# PLANNING BOARD REPORT PORTLAND, MAINE

“118 on Munjoy Hill”  
12 unit residential and 2 unit commercial condominium, 118 Congress Street  
Final Level III Site Plan and Subdivision  
Project ID 2013-255  
118 Condominiums, LLC (Ed Theriault), Applicant

| Submitted to: Portland Planning Board<br>Public Hearing Date: January 28 <sup>th</sup> , 2014 | Prepared by: Jean Fraser, Planner<br>Date: January 24 <sup>th</sup> , 2014 |

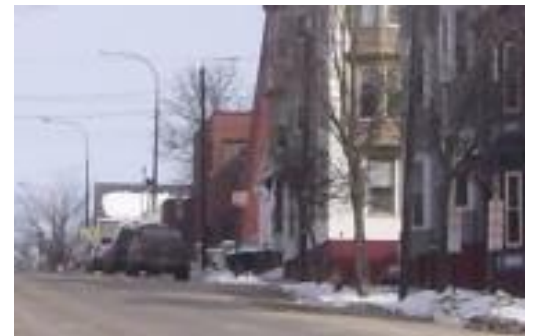
***Tree types** - It would be ideal if the tree types along Congress Street are all the same species. I would recommend the Columnar 'Musashino' Zelkova to be ideal due to the narrow space.*

*See <http://www.jfschmidt.com/articles/musashino> and photo below.*

*The 'Red Sunset' Maple crown shape is too broad for this space. Along Saint Lawrence Street again a more narrow tree is needed, it could be Ginkgo 'Magyar' or 'Autumn Gold' cultivar (seedless), due to narrow sidewalk space.*

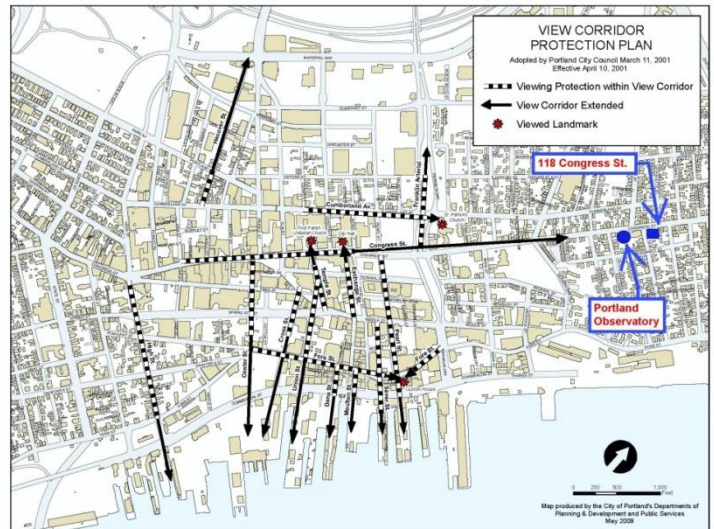
It is noted that the public comments expressed strong concerns regarding the proposed scale of the development and the project has utilized the extra 5 feet in height allowed under zoning to facilitate the mixed use with commercial on the lowest floor. The combination of the height, footprint and elevation design, including decks and living space that overhangs the public sidewalk, creates an imposing building in this part of Congress Street (see the 4 “near” perspectives in [Plan P20](#)).

Staff have not seen any evidence of “diminution in the value or utility to neighboring structures” but there are impacts on the public realm that are discussed under the Subdivision Review and below.
